SUNDRY NOTICES AND REPORTS ON WELLS
Do not use this form for proposals to drill or to re-enter an
abandoned well. Use form 3160-3 (APD) for such proposals.

8. Well Name and No.
SALADO DRAW 29 26 33 FED COM 5H

CHEVRON USA INC RESPECTFULLY REQUESTS TO RELOCATE THE ENTRANCE OF SALADO DRAW PAD 2 TO THE SE SIDE OF THE PAD. THIS WILL ALLOW OPERATIONS TO HAVE ACCESS TO PAD 2 WHILE THE DRILLING RID IS ON PAD 8. CHEVRON HAS A ROW IN THIS AREA IN PLACE AND WE ALREADY REDUCED THE SURFACE DISTURBANCE FOOTPRINT BY COLLOCATING PAD 2 AND PAD 8. IF YOU HAVE ANY QUESTIONS, PLEASE GIVE CALEB BROWN, FACILITIES ENGINEER, A CALL AT 432-687-7326. PLEASE SEE ATTACHED PROPOSED PAD AND ACCESS ROAD AND SURFACE USE PLAT.

CHEVRON U.S.A. INC.
PROPOSED PAD & ACCESS ROAD
SALADO DRAW 29 26 33 FED COM 5H WELL
SECTION 29, T26S-R33E
LEA COUNTY, NEW MEXICO

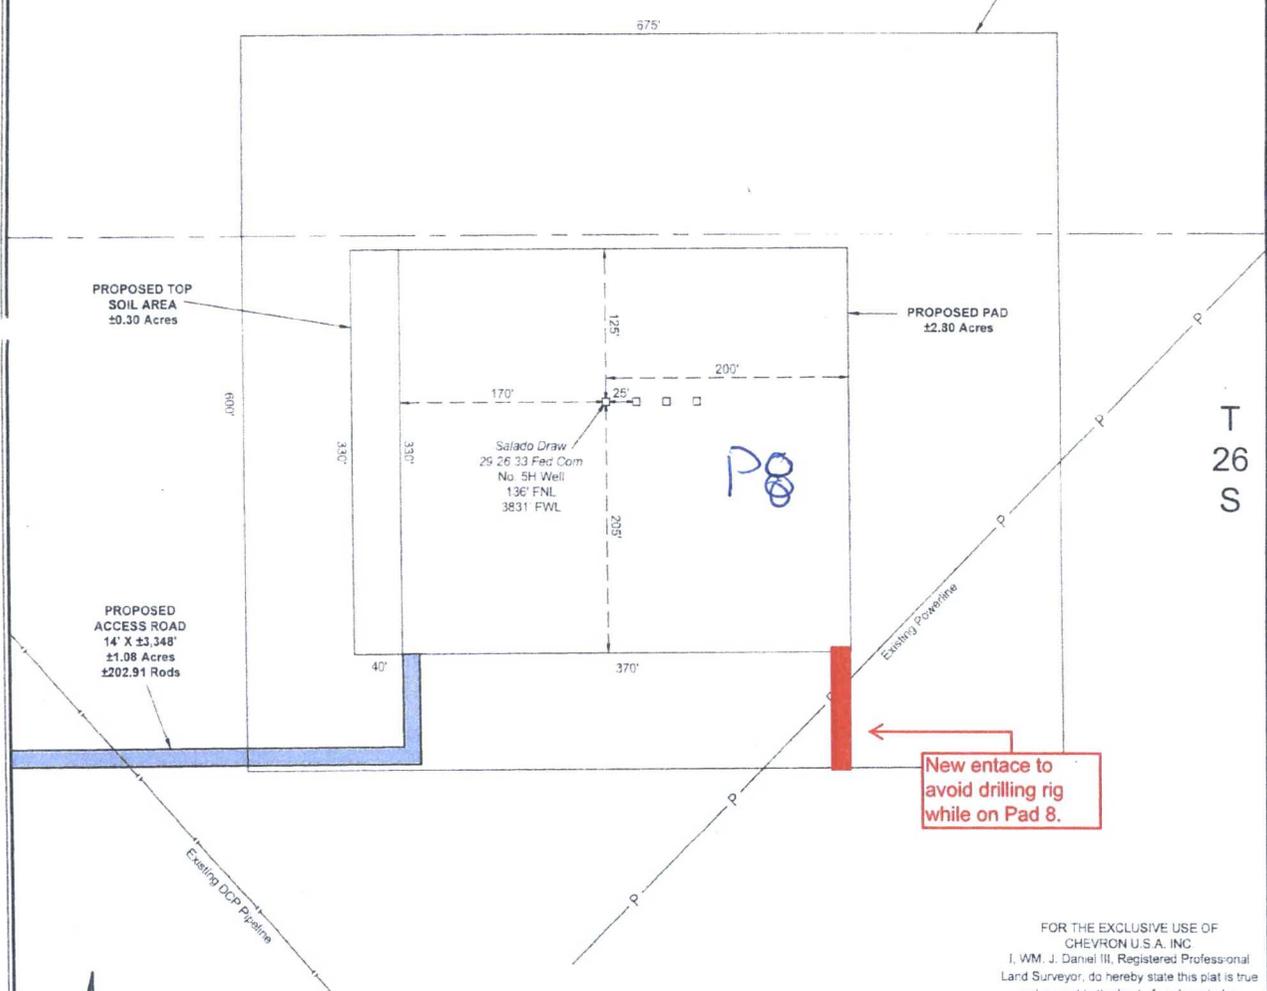
New entace to
avoid drilling rig
while on Pad 8.
